STATE OF MAINE
 DEPARTMENT OF TRANSPORTATION
 16 STATE HOUSE STATION
 AUGUSTA, MAINE
 04333-0016

October 8, 2009
 Subject: **Trenton, Acadia Welcome
 Center**
 Federal Project No. 16123.50
 State Pin No.016123.50
Amendment No. 1

Make the following changes to the Bid Documents:

A1
NO SCALE
DHW HEATING PIPING SCHEMATIC

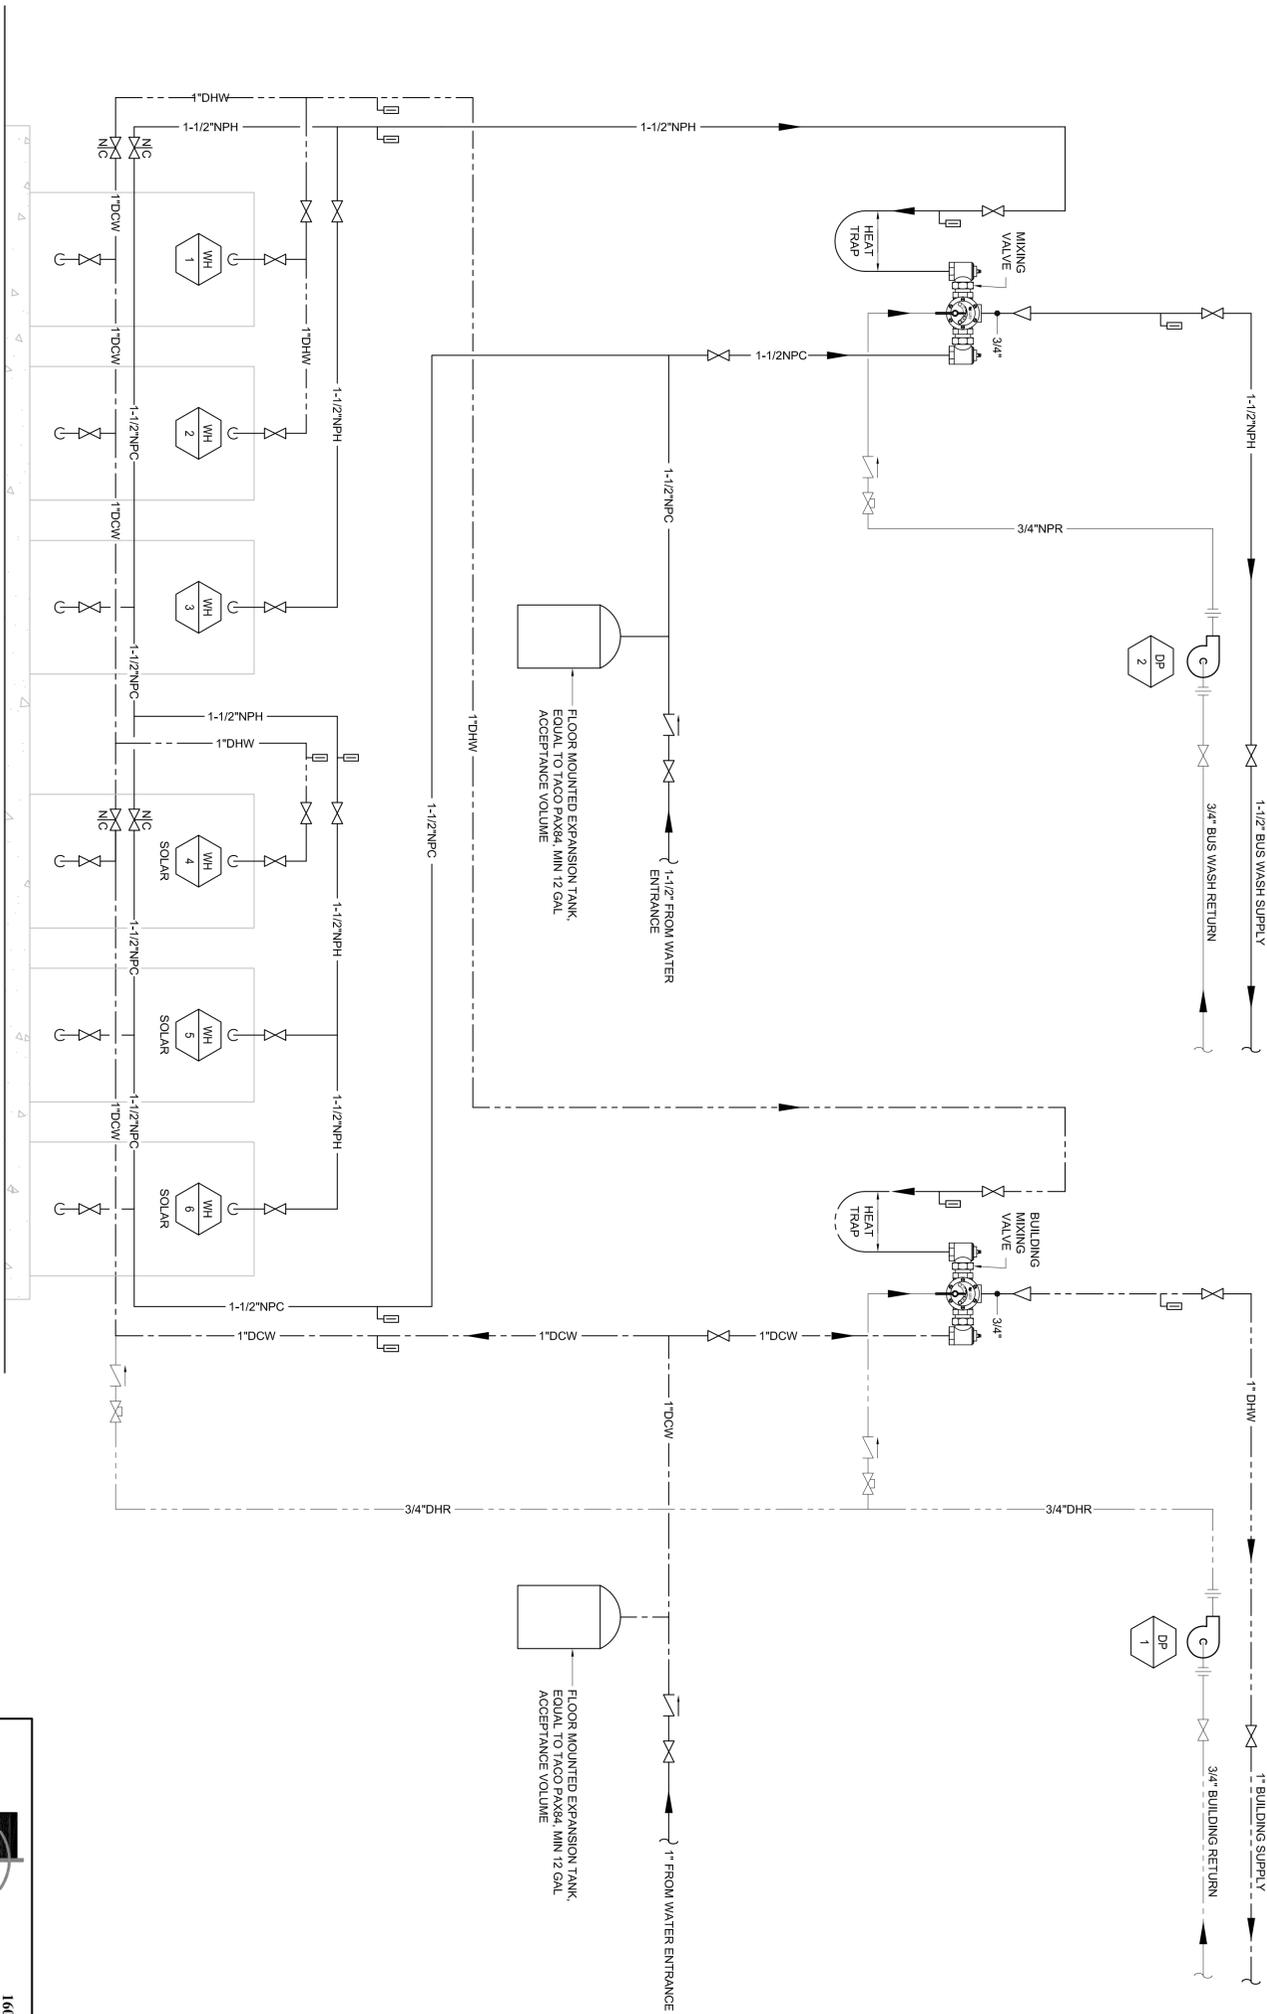
10. DRAWING P-503- Schematic A1, At the water softener, DELETE the following note: “Backwash Hose to Sewer”. ADD in its place: “Backwash Hose to Wash Recycle Room Floor Drain.”
11. DRAWING P-600 – Detail A1, ADD size and model reference to the thermostatic mixing valves as indicated on SKP-2, attached.
12. DRAWING ES-100 - DELETE detail marker D3/ES-500 at the underground electrical between the Bus Maintenance Facility and the Fueling Station. ADD in its place a detail marker D2/ES-500.
13. DRAWING ES-500 - At Detail F8, DELETE two 5” conduits for secondary electric service. ADD in their places two 4” conduits for secondary electric service.
14. DRAWING EP-101 – Refer to attached sketch SKE-01 for receptacles and wiring for lifts to be provided under Option #5.
15. DRAWING EP-400 - At Feeder Schedule, DELETE conduit description for Feeder Tag 9. ADD in its place: IN EACH OF (2) 4”.

Question #1: On page 221119-4 section 2.6 Thermostatic Mixing Valves there is verbiage on the type, which is a Leonard Valve that we represent, but there is no size. On the drawings P-600 it calls for a Potable and a non-potable unit could someone determine the size of these two valves.

Response: Refer to addendum items contained herein for revisions to Sheet P-600 which add information on model and size for the mixing valves.

SKP-01	REVISION TO DETAIL E1/P-500 DOMESTIC WATER ENTRANCE DETAIL	
	MDOT ACADIA GATEWAY FACILITY BUS MAINTENANCE FACILITY	
	Scale: NONE	Project No: 07010
	Date: 10-07-2009	CAD File: 07010_P.DWG

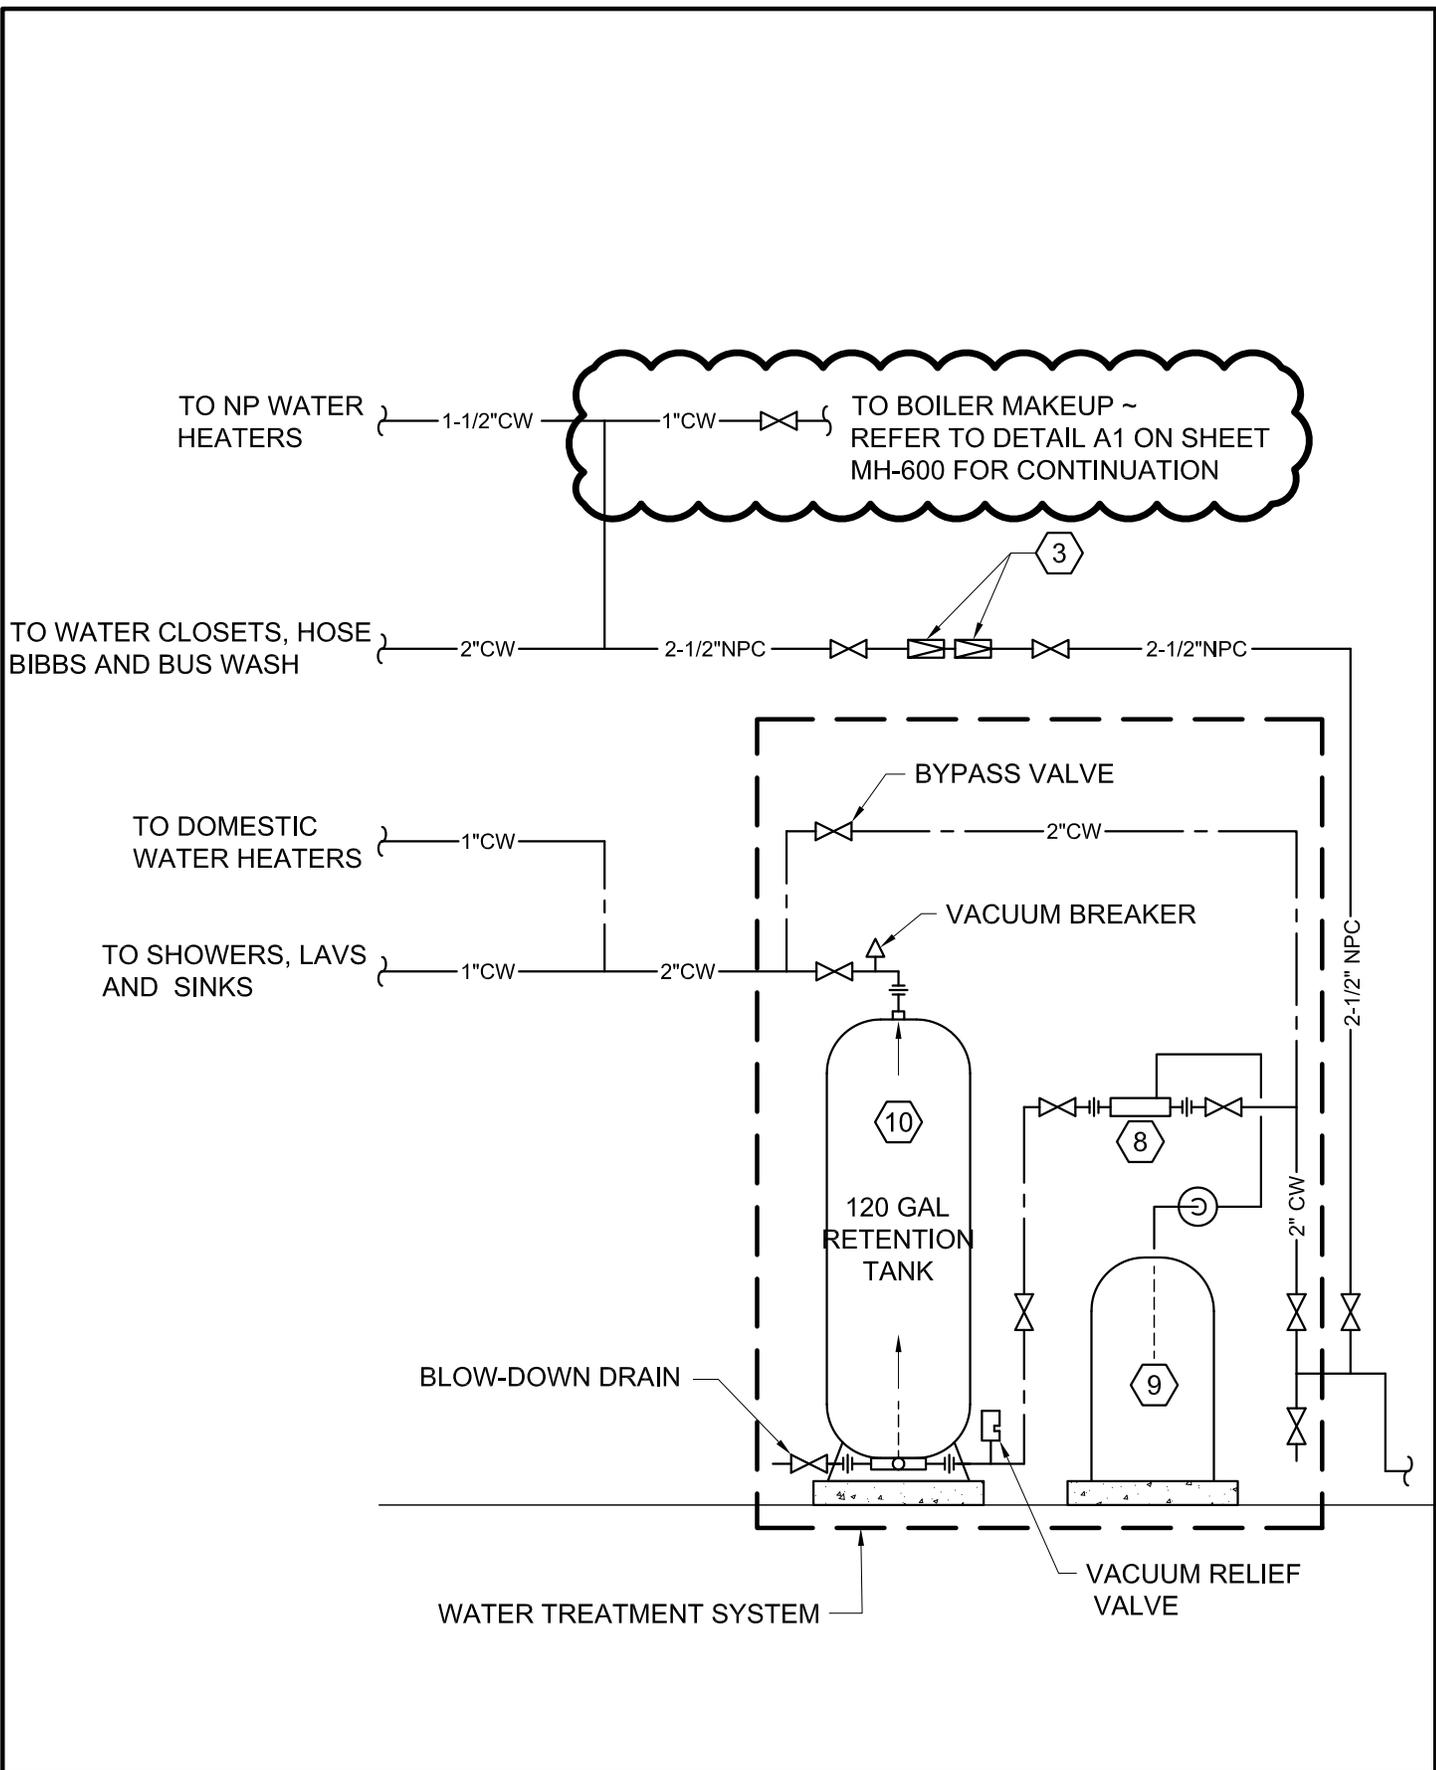
7. DRAWING P-500 – Detail E1, ADD boiler water make-up feed line as indicated on SKP-1, attached.
8. DRAWING P-501 – Detail A1, at the piping blow up part plan DELETE the following note: “2” PVC80 Pipe from City Water Inlet to Eq-Module Circulation Pump Discharge Line For Pit Fill Pipe Line”. ADD in its place: “2” PVC80 NPC to Eq-Module Circulation Pump Discharge Line For Pit Fill Pipe Line”.
